SUBJECT: Indian Point Nuclear Generating Unit No.3
Docket No. 50-286
**Reply to Request for Additional Information
Regarding Proposed License Amendment for
1.4% Measurement Uncertainty Recapture Power Uprate**

Clarification; Response to Question 5, Indian Point 3 RAI dated 8/26/02

This information supplements and clarifies the response to the subject RAI, which asked: "Were the flow elements [to be used in the IP 3 uprate] tested in a plant specific geometry?"

Figure 1

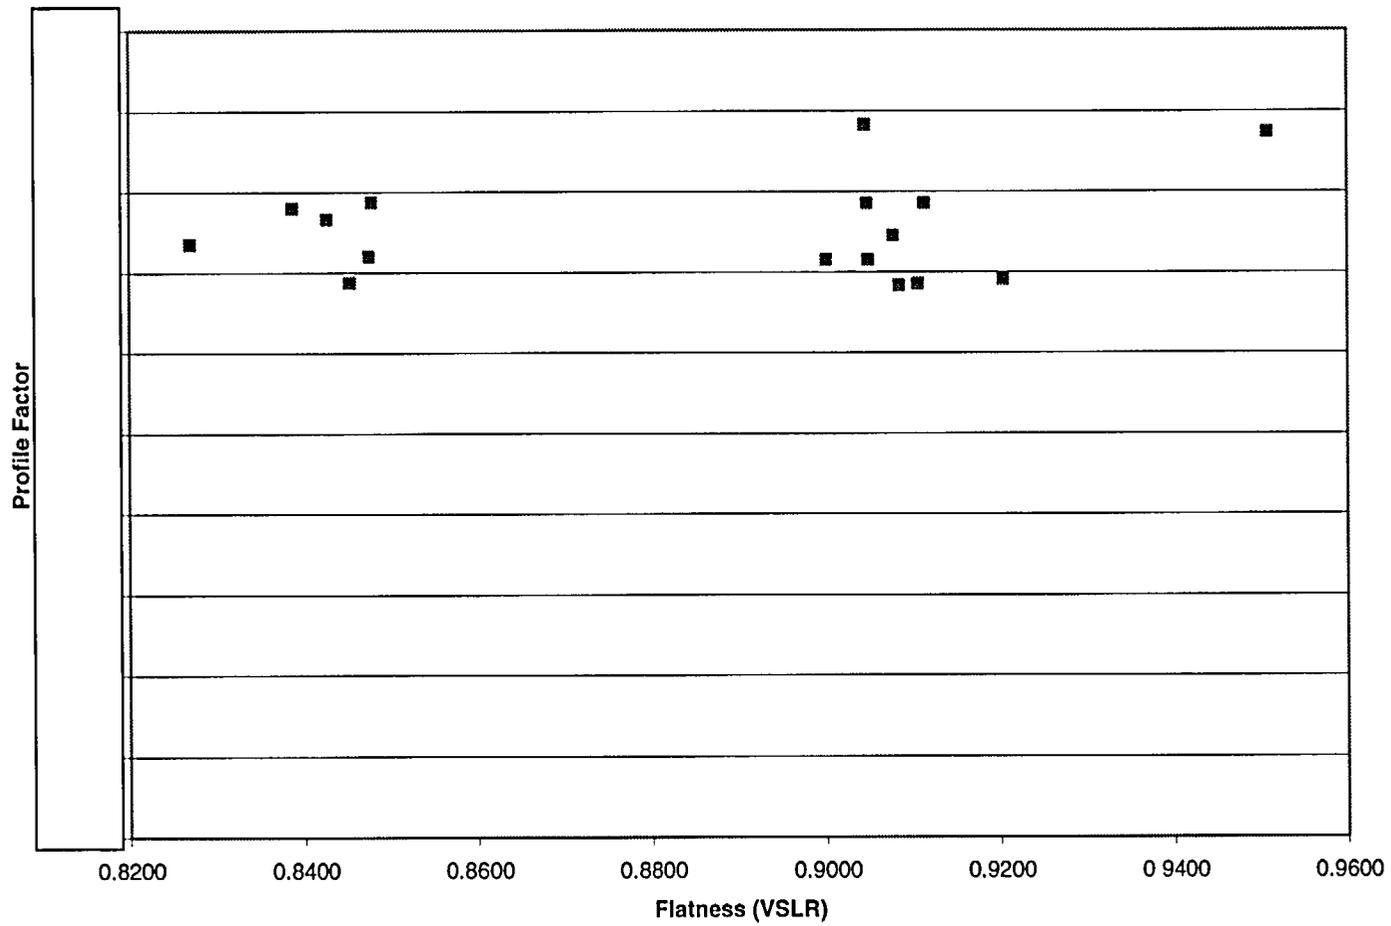
Results are shown in Figures 1 and 2. Figure 1 shows the sensitivity to flatness. The cluster of data on the left—for flatness in the 0.83 to 0.85 range—are the straight pipe data. The cluster of data on the right—flatness 0.90 and up—are with complex upstream geometries. The latter group embraces the flatness ratios measured at IP 3. The mean Profile Factors for the two data sets are essentially the same— [REDACTED] band about the straight pipe mean bounds all the data, including some for hydraulic conditions substantially more extreme than those at IP3.
